1. PCI-SIG ENGINEERING CHANGE NOTICE

TITLE:	PCIe BGA SSD 11.5x13 ECN
DATE:	January 25, 2017
AFFECTED DOCUMENT:	PCI Express M.2 Specification, Revision 1.1
SPONSOR:	HP, Intel, Lenovo, Micron, Samsung, SanDisk, Seagate, Toshiba

This proposal adds a new 11.5 mm x 13 mm PCIe BGA SSD form factor to the M.2 v1.1 specification.

Figure 3. M.2 Naming Nomenclature

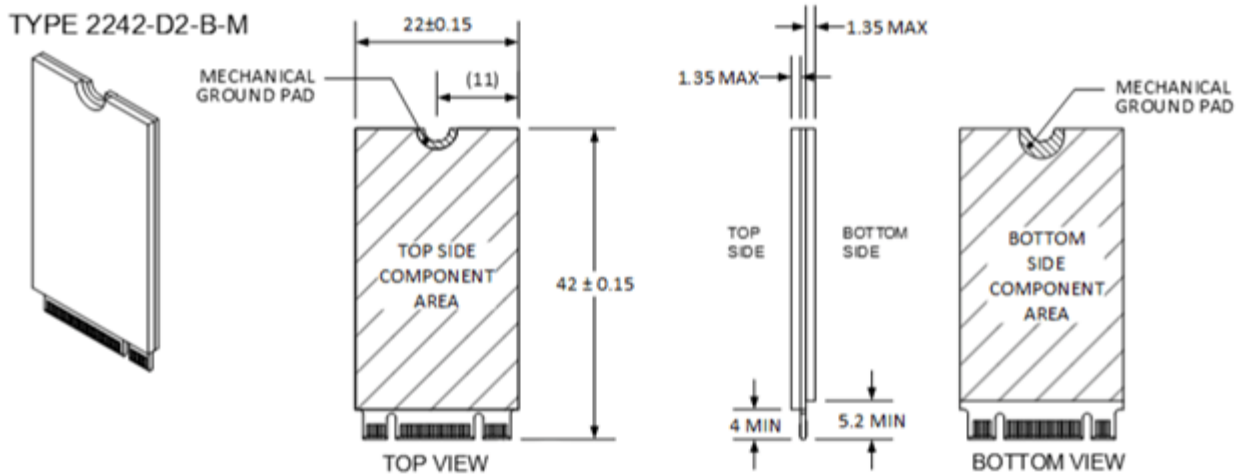
The module width options are: 11.5 mm, 12 mm, 16 mm, 16.5 mm, 20 mm, 22 mm, 28 mm, and 30 mm.

The module length can scale to various lengths to support the content and expand as the content increases. The lengths supported are: 13 mm, 16 mm, 20 mm, 24 mm, 26 mm, 28 mm, 30 mm, 42 mm, 60 mm, 80 mm, and 110 mm.

Figure xx M.2 Type 1113 S5 Mechanical Outline Drawing Example

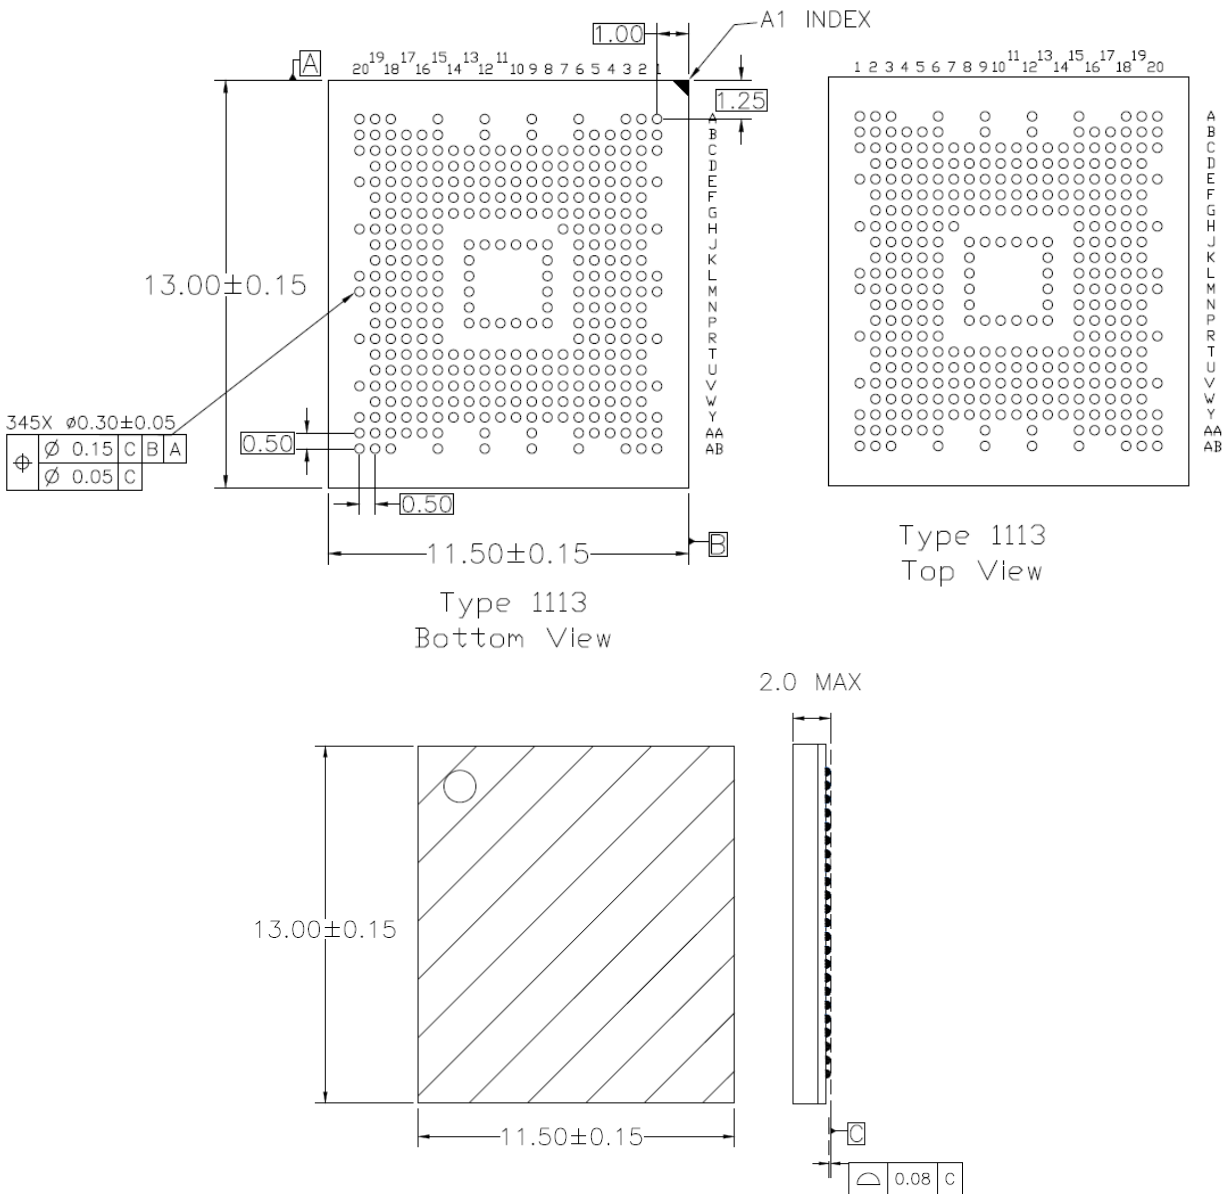
2.3.6.1. Type 1113 Specification

The BGA package size of 11.5 mm x 13 mm contains the ball map for Type 1113.

Figure xx shows the mechanical outline drawing for BGA Type 1113 and Figure yy shows a recommended land pattern for the Type 1113 package. The dimensions shown in Figure yy are nominal.

Figure 105. Type 1620 BGA Module-side Ballmap Surrounded by Type 2024, Type 2228, and Type 2828 Module-side Ballmaps (Top View)

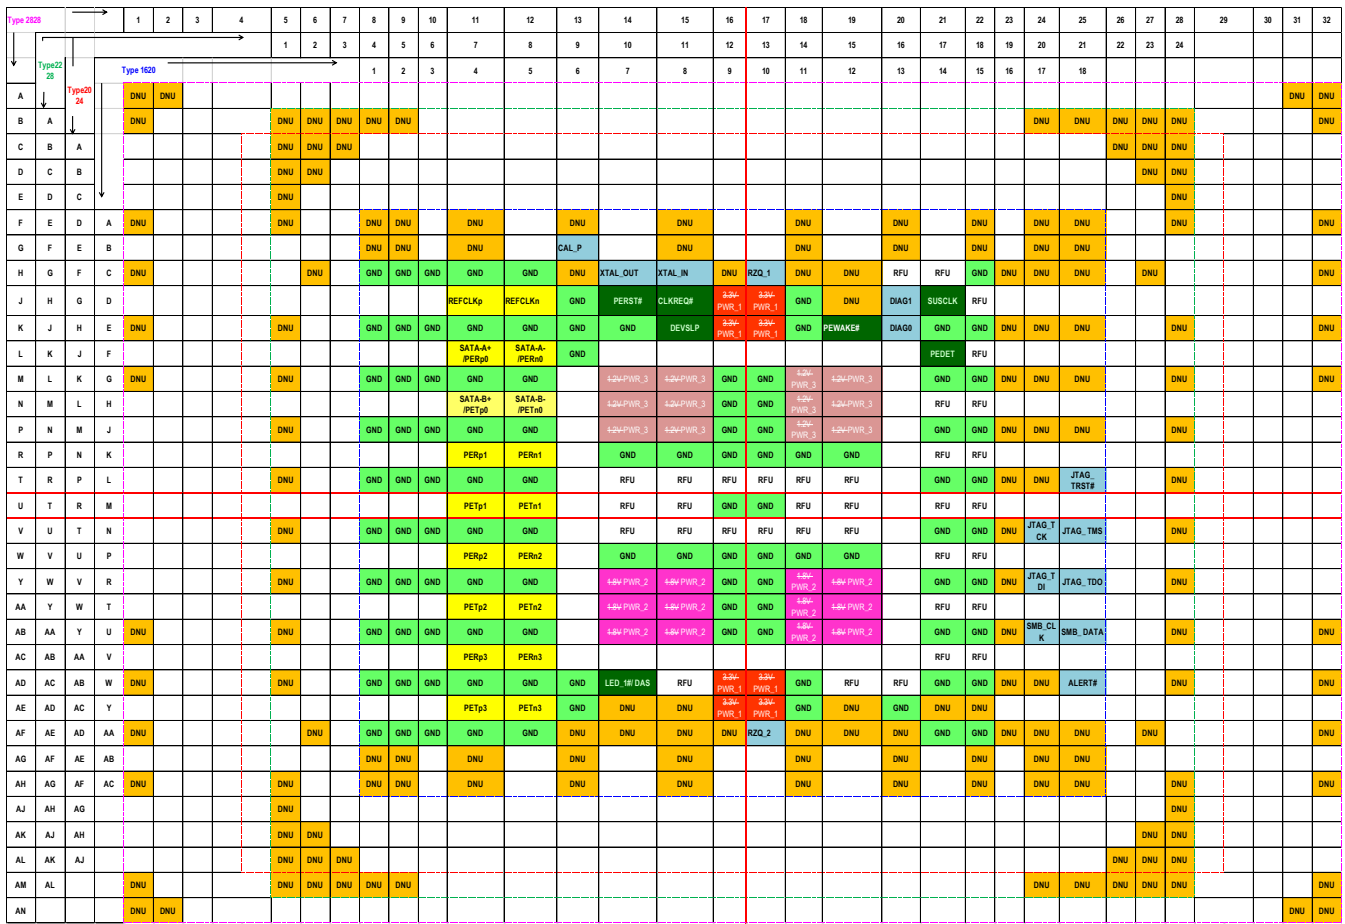
Figure 105 shows Type 1620 BGA module-side ballmap surrounded by Type 2024, Type 2228, and Type 2828 module-side ballmaps (Top View). There are additional sizes of 20 mm x 24 mm, 22 mm x 28 mm, and 28 mm x 28 mm defined for BGA SSD. Ballmaps for ~~the Types 2024, 2228, and 2828~~ ~~these sizes have encompass the Type 1620 ballmap with~~ additional DNU balls for mechanical stability. See section 2.3.6, Soldered-Down Form Factors for BGA SSDs for details on the location of these DNU balls for various BGA package sizes.

[Editor's note: For reviewers of this ECR, the changes in the BGA ball-out tables for Types 1620, 2024, 2228, and 2828 are in the labeling of the cells describing the power rails (i.e., used to be specific voltages, and are now PWR_1, PWR_2, PWR_3.)

Figure 106. Power-on Sequencing

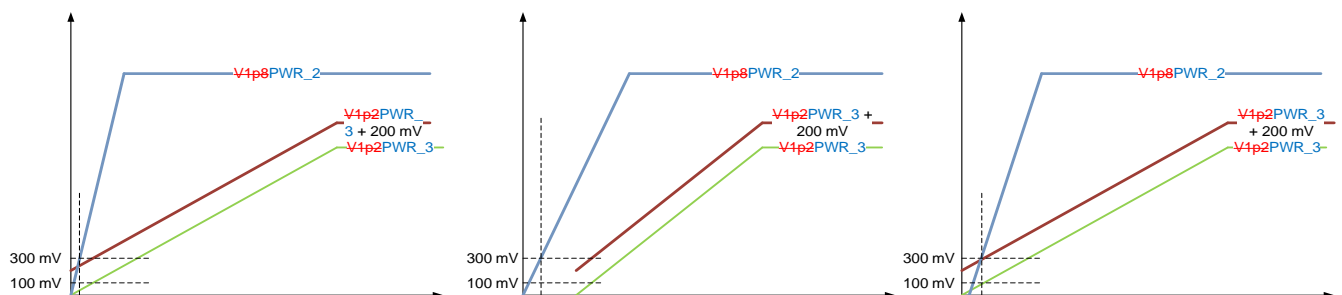
The host should apply the following recommendations for sequencing the voltages on the **3.3 V PWR_1** supply, the **1.8 V PWR_2** supply, and the **1.2 V PWR_3** supply during power-on:

- After the voltage on the **1.8 V PWR_2** supply or the voltage on the **1.2 V PWR_3** supply reach 300 mV, the voltage on the **1.8 V PWR_2** supply should remain greater than the voltage on the **1.2 V PWR_3** supply by at least 200 mV.
- The voltage on the **3.3 V PWR_1** supply has no timing relationship relative to the voltage on the **1.2 V PWR_3** supply or the voltage on the **1.8 V PWR_2** supply.

Figure 106 shows three valid power-on ramp examples for the case where each of the power rails is assigned a different voltage. The 1st example shows PWR_2 reaching 300mV before PWR_3 reaches 100mV. The 2nd example shows PWR_2 well above 300mV by the time PWR_3 reaches 100mV. The 3rd case shows PWR_2 reaching 300mV at the same time as PWR_3. [Note: The PWR_1 rail is not shown since it has no timing relationship to the other rails.]

Figure 107. Power-off Sequence

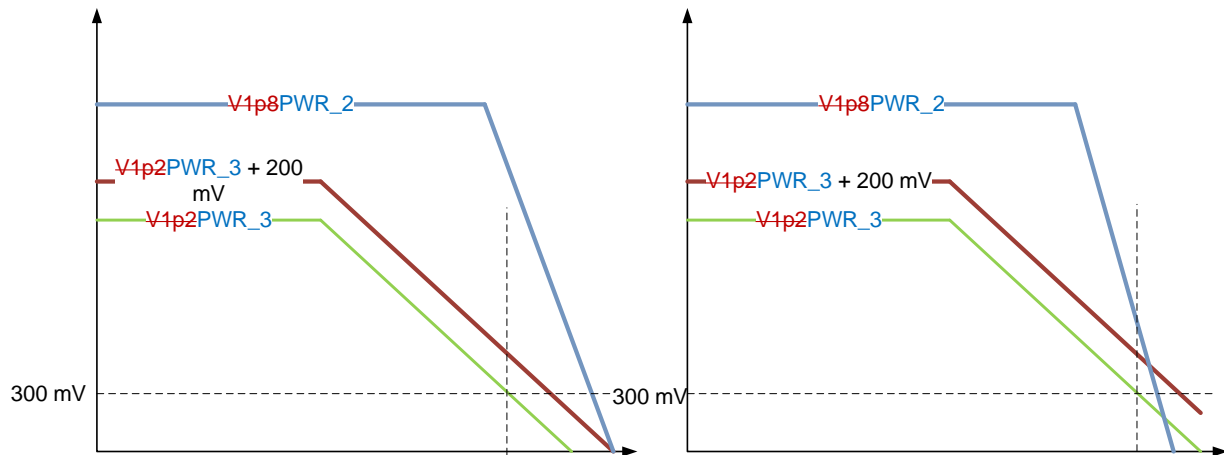
The host should apply the following recommendations for sequencing the voltages on the 3.3V-PWR_1 supply, the 1.8V-PWR_2 supply, and the 1.2V-PWR_3 supply during power-off:

- ❑ Before the voltage on the 1.2V-PWR_3 supply and the voltage on the 1.8V-PWR_2 supply reach 300 mV, the voltage on the 1.8V-PWR_2 supply should remain greater than voltage on the 1.2V-PWR_3 supply by 200 mV.
- ❑ After both the voltage on the 1.8V-PWR_2 supply and the voltage on the 1.2V-PWR_3 supply are below 300 mV, there is no specified relationship between them.
- ❑ The voltage on the 3.3V-PWR_1 supply has no timing relationship relative to the voltage on the 1.2V-PWR_3 supply or the voltage on the 1.8V-PWR_2 supply.
- ❑ The voltage on all supplies should remain below 100 mV for at least 1 ms before the power-on sequence is restarted.

Figure 107 shows two valid power-off ramp examples for the case where each of the power rails is assigned a different voltage. [Note: The PWR_1 rail is not shown since it has no timing relationship to the other rails.]
